ENVIRONMENTAL REVIEW TEAM REPORT

HARWINTON WOODS SUBDIVISION

HARWINTON, CONNECTICUT

NOVEMBER 1978

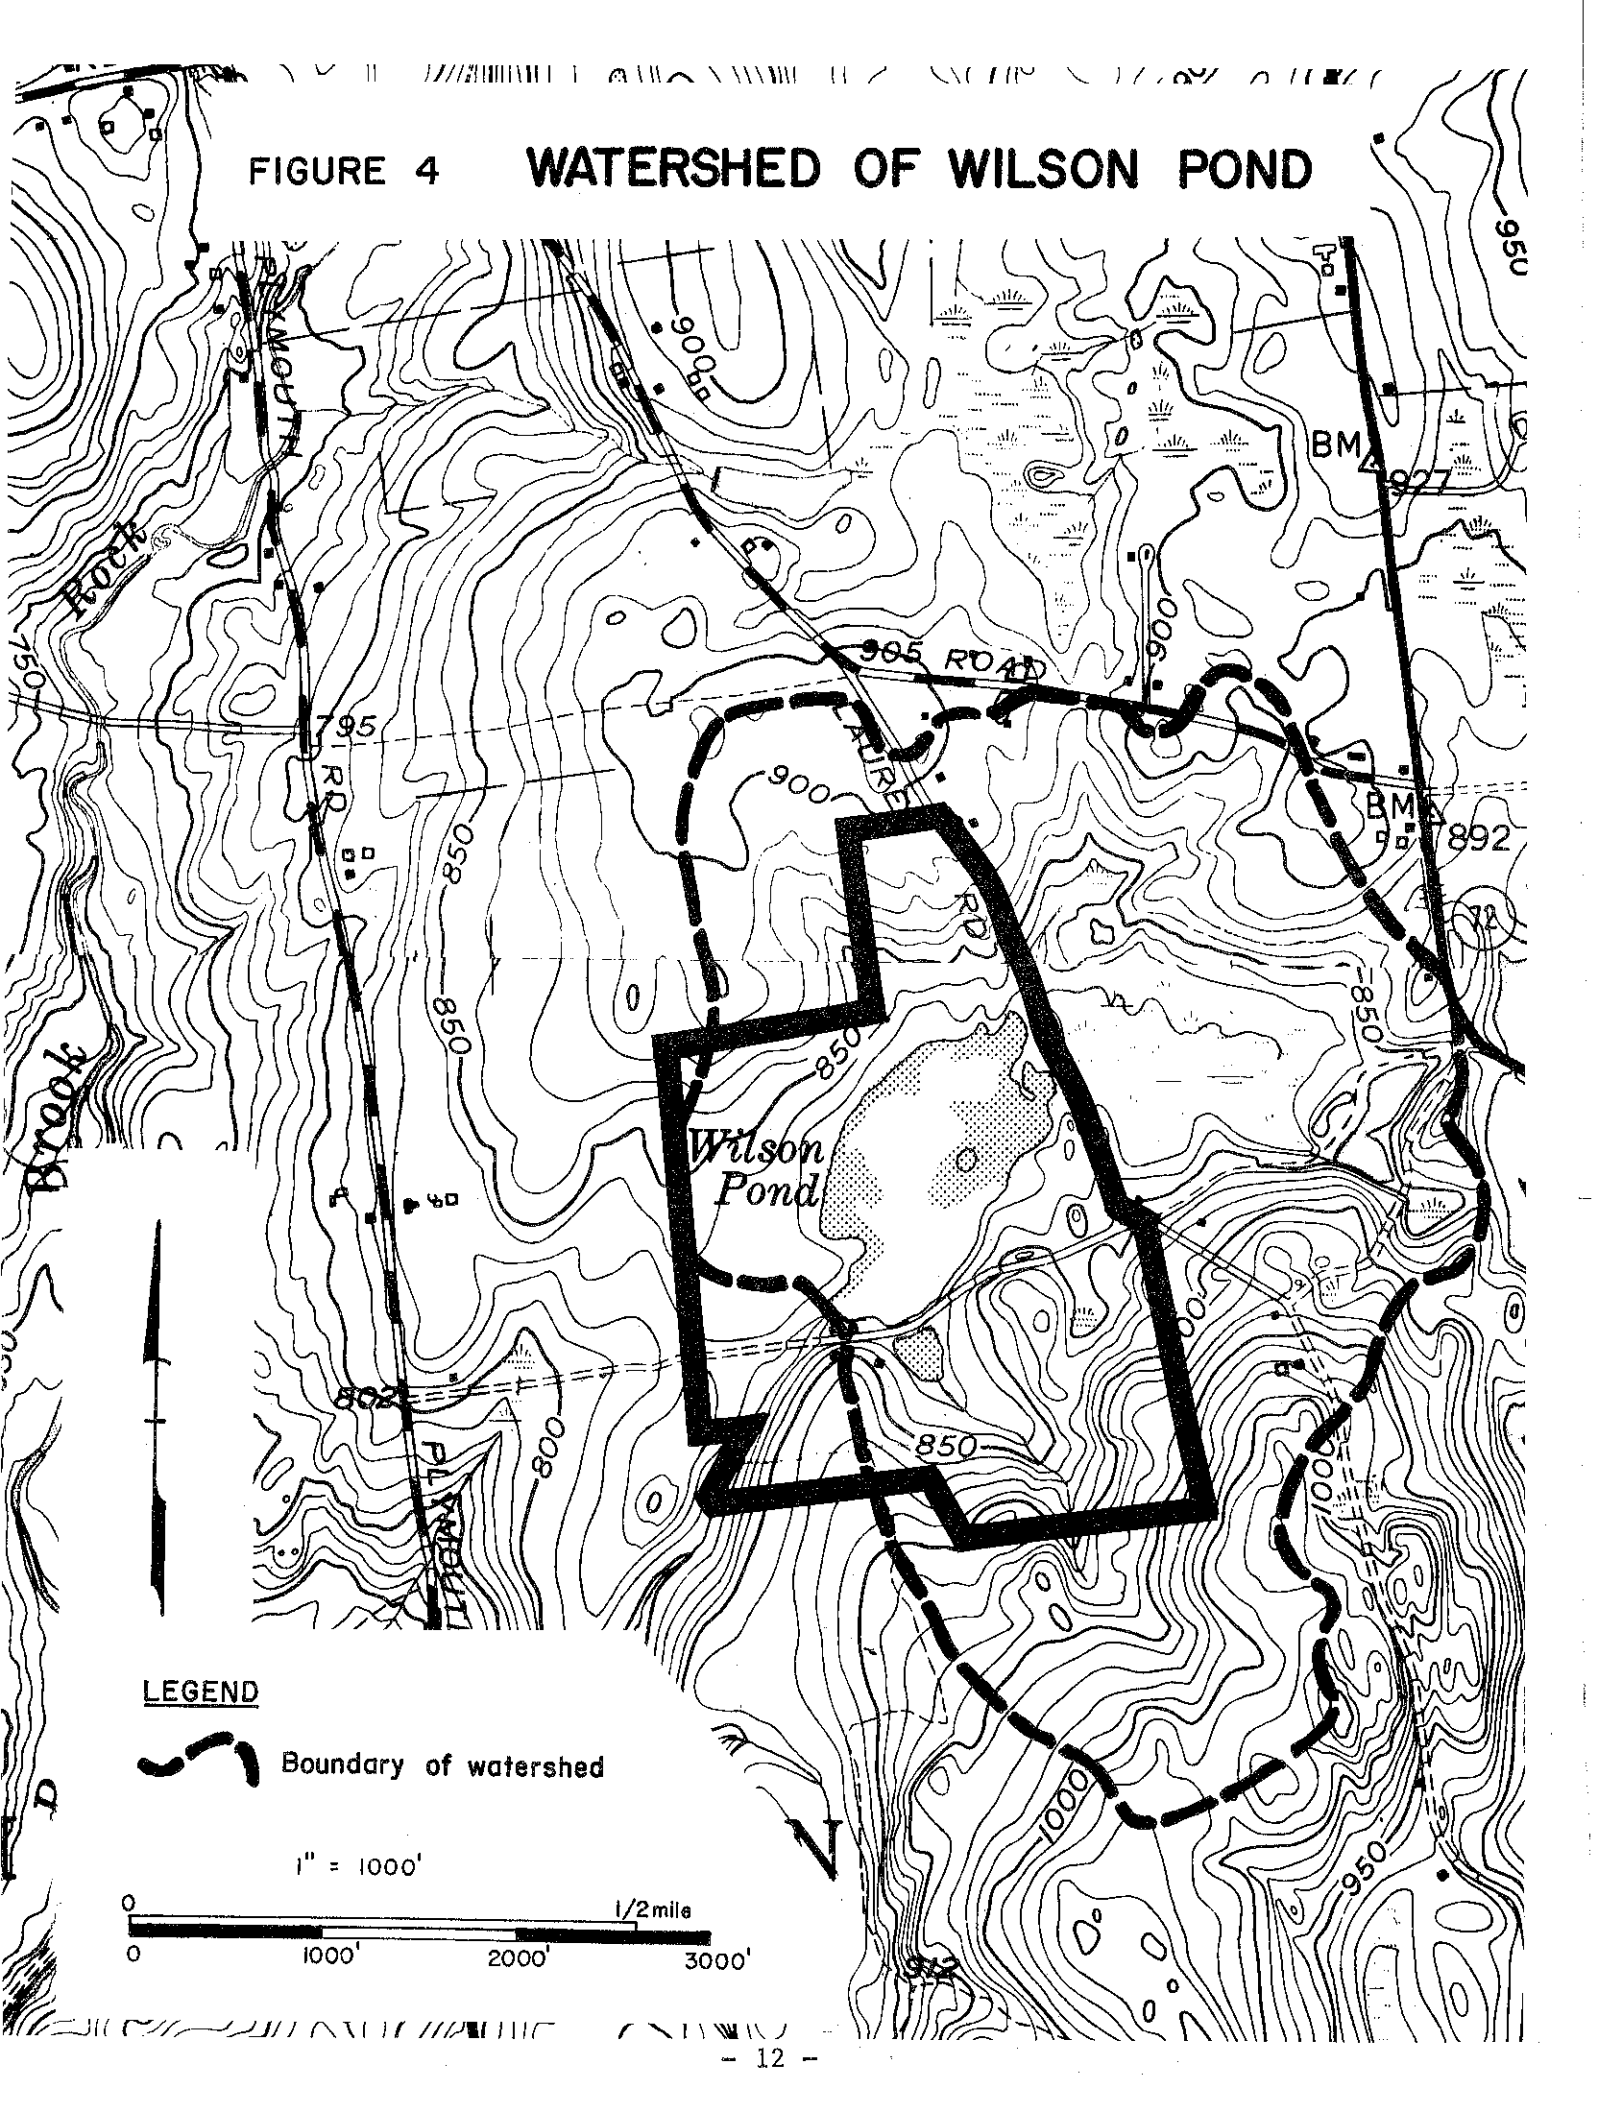
Wilson Pond is fed by surface and groundwater runoff from a drainage area of approximately 413 acres (See Figure 4). Land use changes, if restricted to the current proposals, should affect no more than 40 acres, or about one tenth, of the overall watershed. The increases in runoff that will result from development may be estimated by a method outlined in Technical Release No. 55 of the Soil Conservation Service. Table 1 lists such estimates for 24-hour storms of 10-year, 50-year, and 100-year intensities; that is, for storms of 24-hour duration that occur on an average basis of once every 10, 50, and 100 years, respectively. (Another way to view these storms is to say that they have a 10 percent, 2 percent and 1 percent chance, respectively, of occurring in any given year.) The numbers presented in the table are not necessarily precise; they are meant to provide only a "ballpark" guide to the magnitude of expected runoff changes.

It must be remembered that the runoff increases predicted in Table 1 are for the Wilson Pond watershed as a whole. The percentage of increases in runoff from the immediate areas of development will be much greater. For instance, during a storm that produced 2 inches of rain, it is estimated that more than four times the current volume of runoff would be generated from a developed acre. During a storm that produced 5 inches of rain, approximately 90 percent more runoff would flow from a developed acre. These figures highlight the importance of adequate sediment and erosion-control measures on the property, particularly near the wetlands.

VEGETATION TYPE MAP

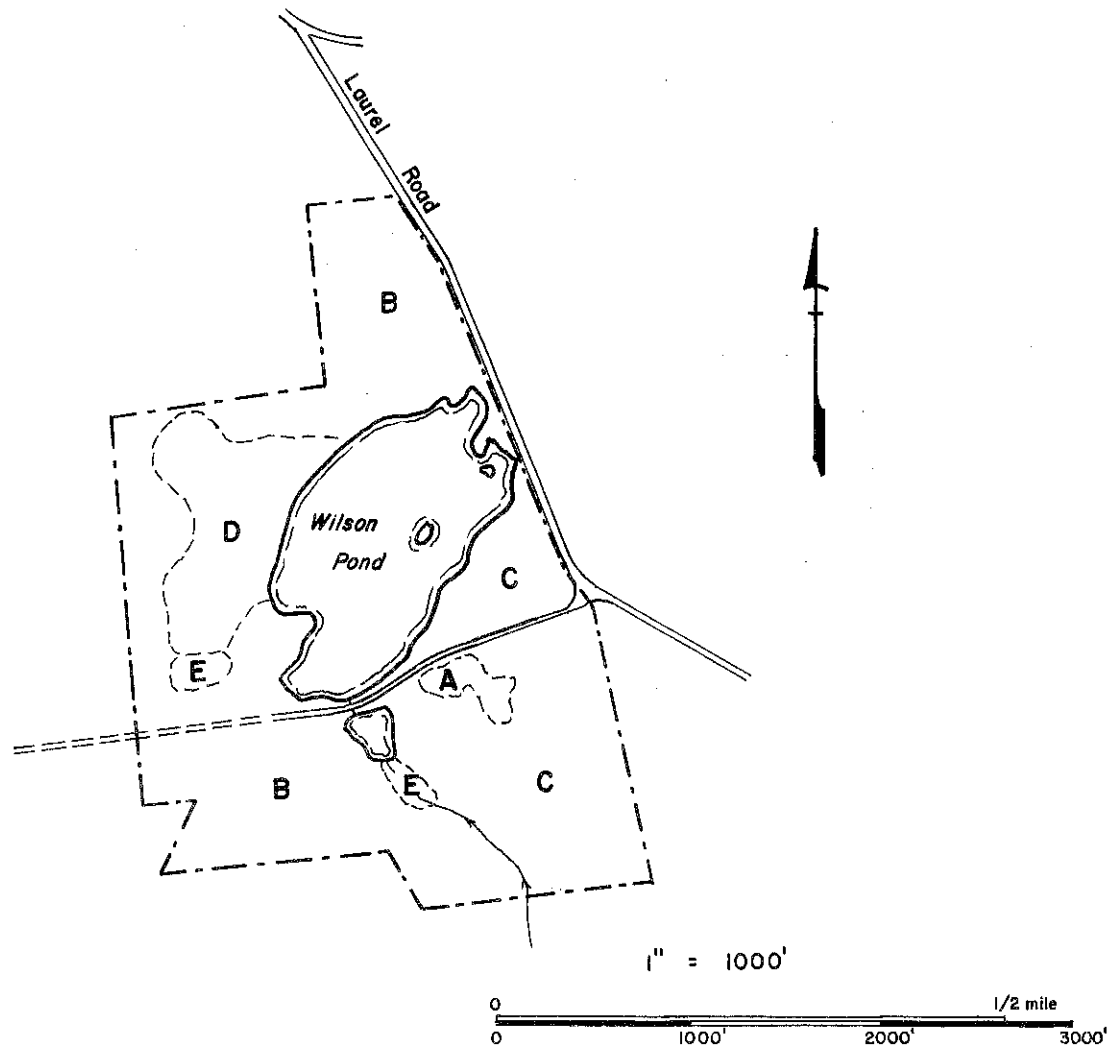
It would be highly desirable to thin Types A and C (See Figure 5) as soon as possible. The high density of white pine in Type A has made this stand susceptible to wind, ice and snow damage. Type C is approaching the stage at which competition between crowded trees causes a decline in the health and vigor of most of the trees; this trend may lead to the eventual death of over half of the existing trees. The thinning should be directed by a private forester and should yield enough fuelwood (about 2 cords per acre) to cover the cost of the operation.
